**Subject: Addendum #2 Panama City Beach Lift Station #4 Replacement Project**

We are submitting this addendum notification letter and attached information for the City of Panama City Beach Lift Station #4 Replacement Project (RFP# 03.04.21.RFP-Lift Station #4 Replacement Project). The ISS Team has reviewed the questions, updates, and attachments to be included and prepared them within the addendum as an addenda item or enclosure to this document.

## **ADDENDUM #2**

**Self-Closing Gate**

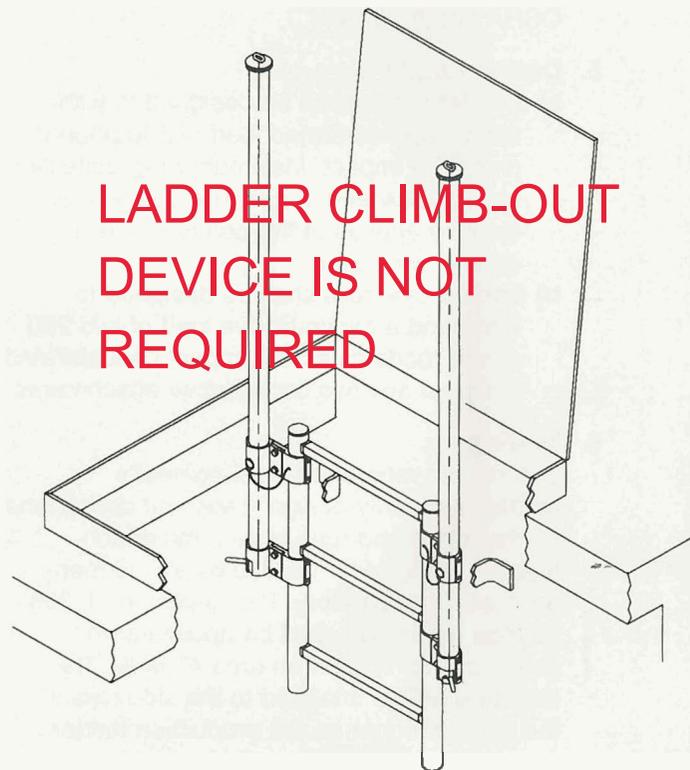
*The ladder walk-through may require a self-closing gate in accordance with OSHA 1910.23.*

Every ladderway floor opening or platform shall be guarded by a standard railing with standard toe board on all exposed sides (except at entrance to opening), with the passage through the railing either provided with a swinging gate or so offset that a person cannot walk directly into the opening. Self-closing gates are required only where shown on plans.

Answer: Plan Sheet S-103, A1/S-103: The method of anchoring the tube railings (keynote 5-9.02) to the top wall of the Valve Vault shall be entirely by use of manufactured post base flanges. No recessed sleeves into the top of concrete walls will be allowed, no anchoring grout is required. Plan Sheet S-103, A1/S-103: Refer to the Thompson’s Aluminum TufLadder Specifications attached for the requirement of the step-thru aluminum ladder and self-closing gate.

**Ladder Climb-out Device**

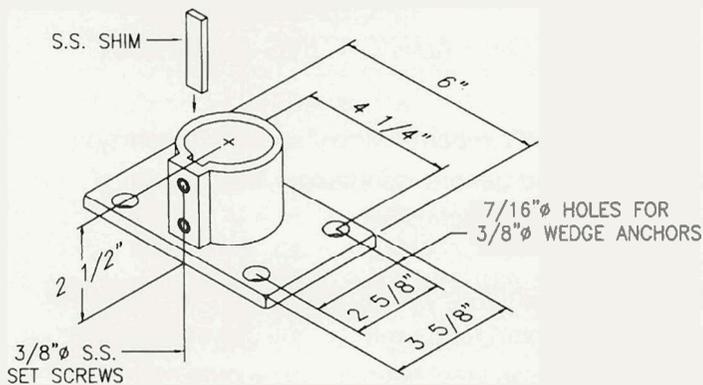
**LADDER CLIMB-OUT  
DEVICE IS NOT  
REQUIRED**
